MEMORANDUM

From:	Built Heritage Officer		
Service	Green Infrastructure	App No:	243127 + 243128
Address:	URS Building, Whiteknights Campus, Earley, RG6 6BW.		
Proposal:	243127: Full application for proposed external and internal refurbishment, repairs and alterations consisting of replacement windows and doors; replacement roofs, including new roof lights, cowls, and lanterns; installation of solar panels; concrete repairs; full mechanical and electrical services upgrade; erection of two external staircases; new detached bin and bike store; and hard and soft landscape and accessibility improvements. 243128: Listed Building consent for proposed external and internal refurbishment, repairs and alterations consisting of replacement windows and doors; replacement roofs, including new roof lights, cowls and lanterns; installation of solar panels; concrete repairs; full mechanical and electrical services upgrade; erection of two external staircases; new detached bin and bike store, and hard and soft landscape and accessibility improvements.

Heritage Asset:	URS Building – grade II listed building status since 2016. Whiteknights Park – Local Historic Park & Garden classification made by t

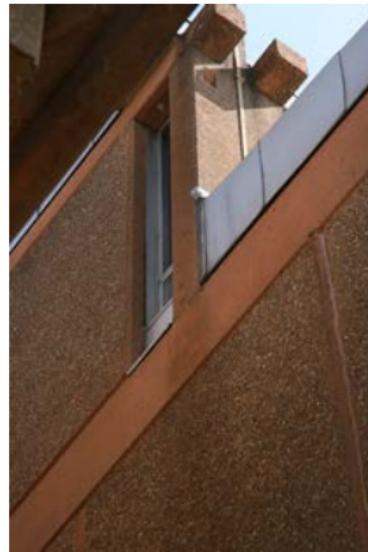
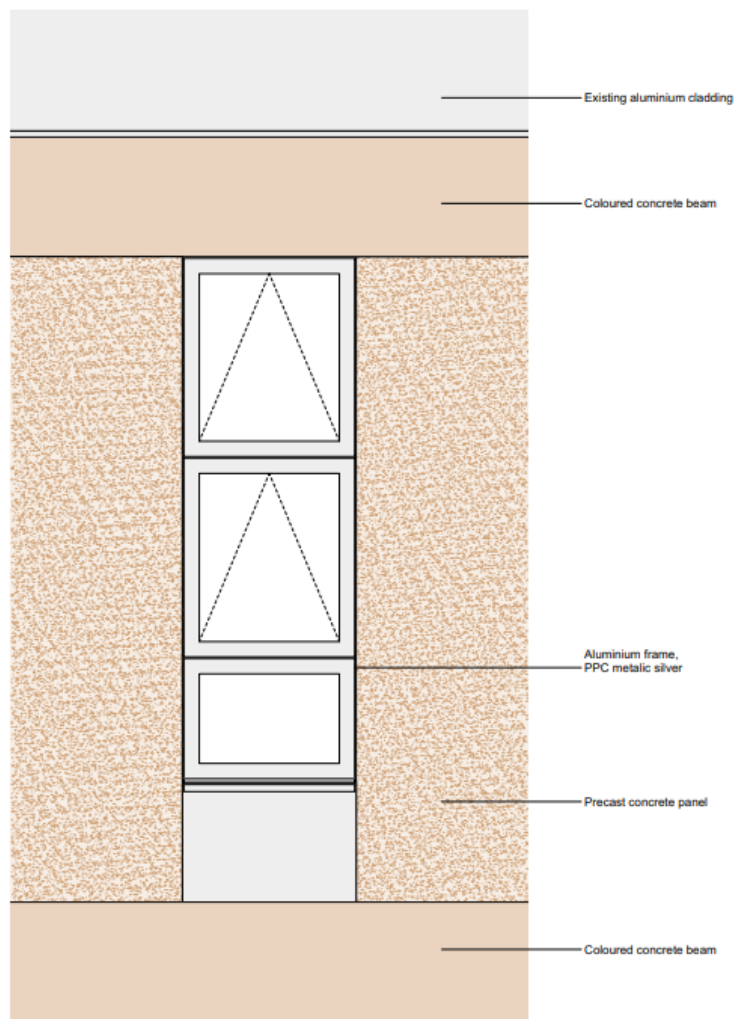
without further details being provided, which could be dealt with by means of a condition. The drawings for the windows do not seem to account for all the window forms of the building (attached below are photographs of various windows taken from the insufficient to understand what actual form and details for these elements, or the case of the windows as not all the variations in their design are not believed to be sufficiently detailed.

2360383-ACG-W033-ZZ-DR-A-42296 Rev.P

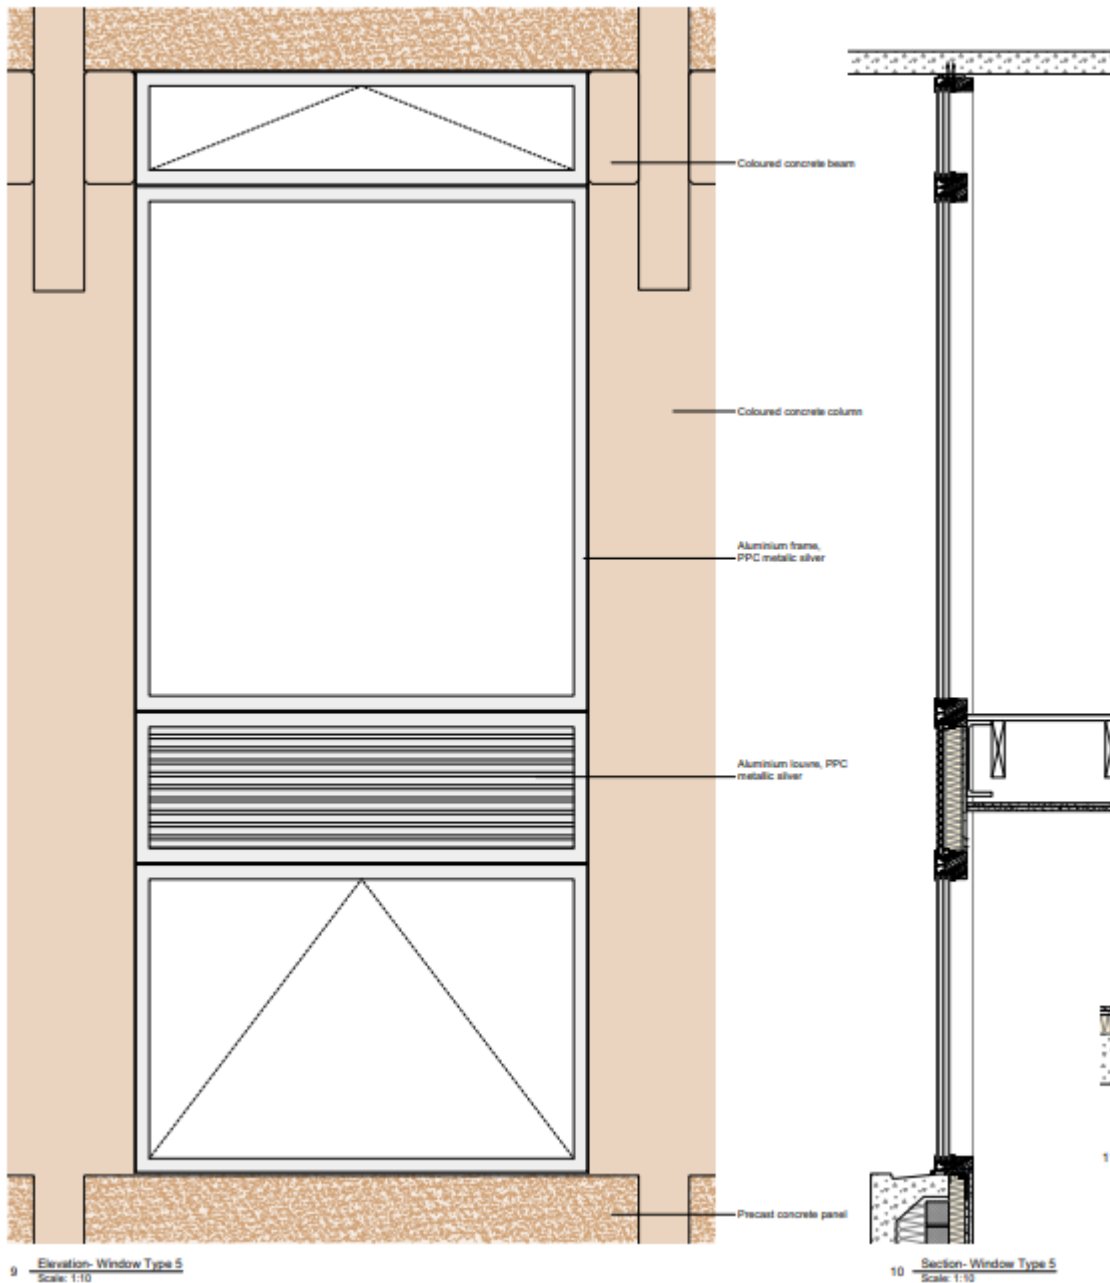
2360383-ACG-W033-ZZ-DR-A-42296 – here the cross-section drawing is stated to be Window Type 1, and the lower panel does not seem to relate to that shown elevation view.

2360383-ACG-W033-ZZ-DR-A-42296 Rev P this drawing does not make clear whether the solid panels of the window are to be new powder coated ones to match with the material and finish of frames.
